BMS SECTION

Title		MAIN BOARD		SFO Technologies Pvt Ltd- R&D Solutions division.	
Page Content :		BMS			
Size	Document Number	Ver		FMT NO:EA.007	
A3	50-595-0001-S	5.0		VER.1	
Date:	Thursday, January 05, 2023	Sheet	4	of	6

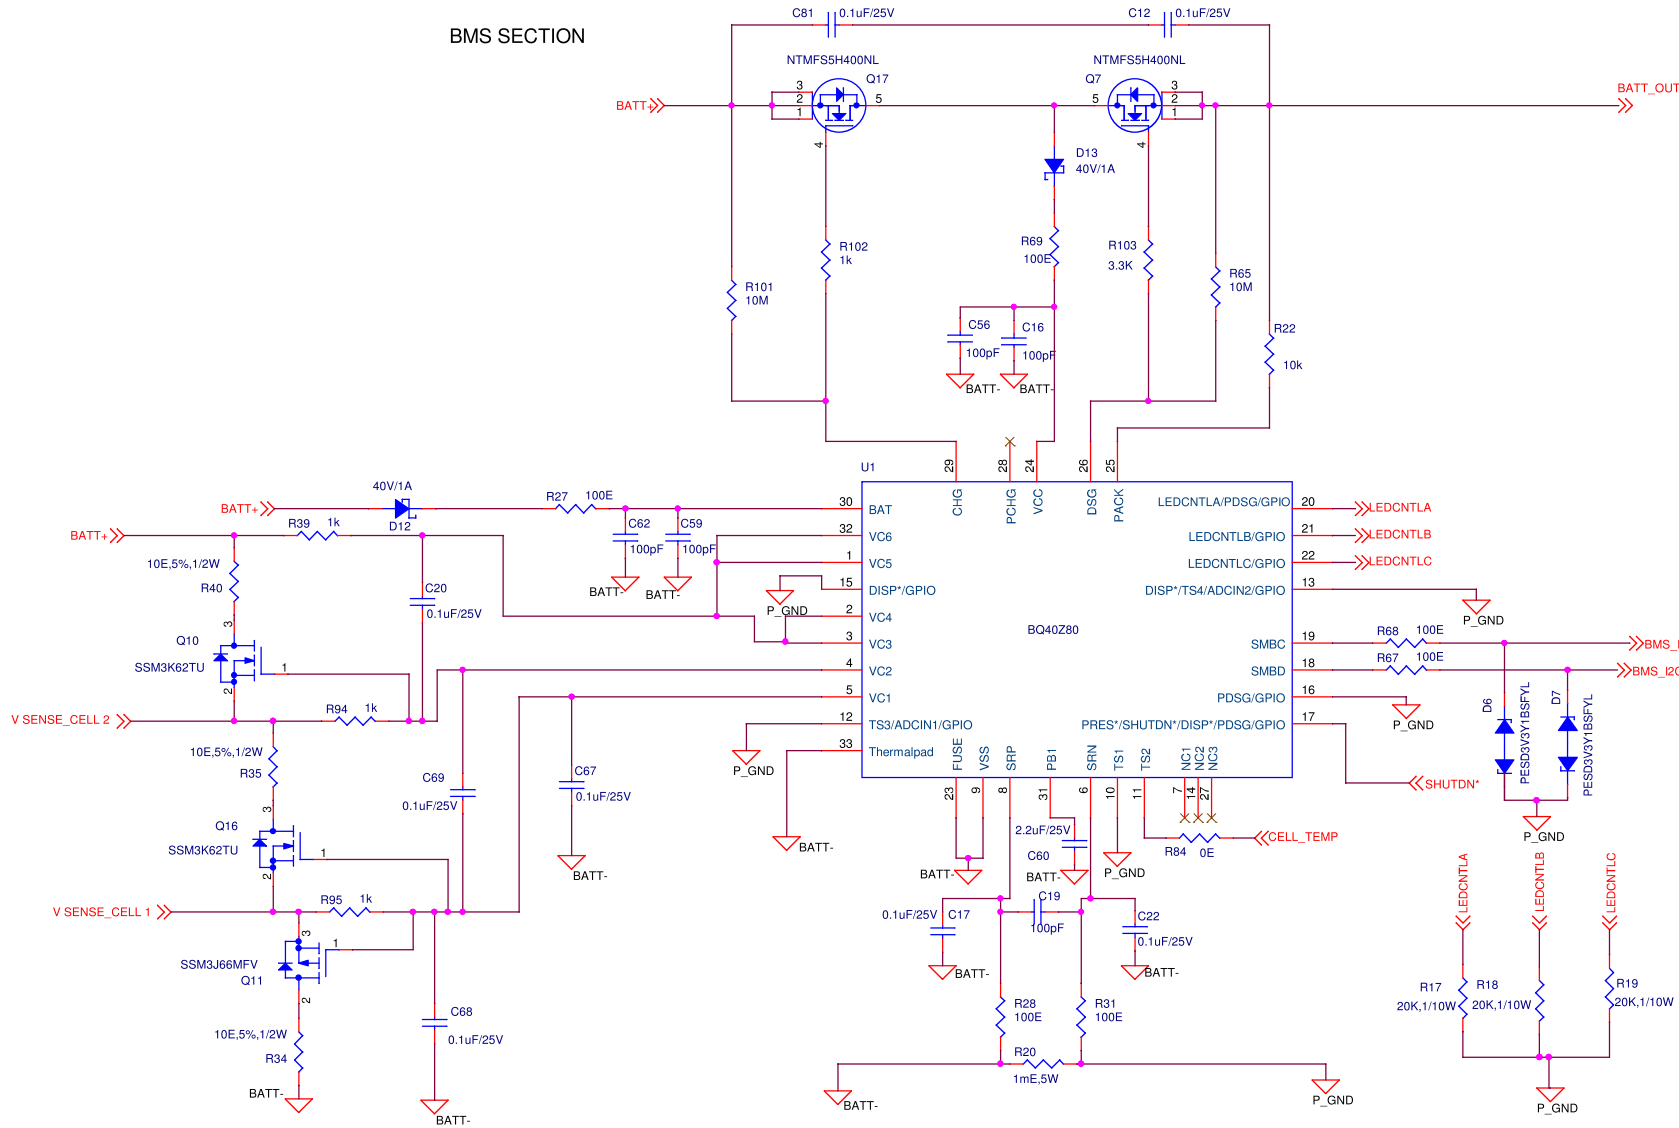
NOTE: PINS 2 AND 3 OF Q11 is interchanged in PCB

NOTE : Care should be taken while soldering M2 and M3 since GND vias are near to mounting holes

CELL TEMPERATURE SENSE

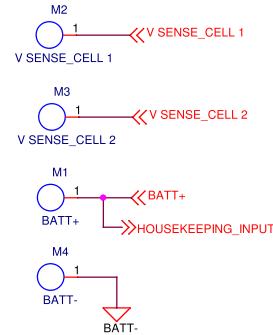
Note:provide through hole pad for TP6 and TP7
TP6 is not connected instead one end of thermistor is connected to GND
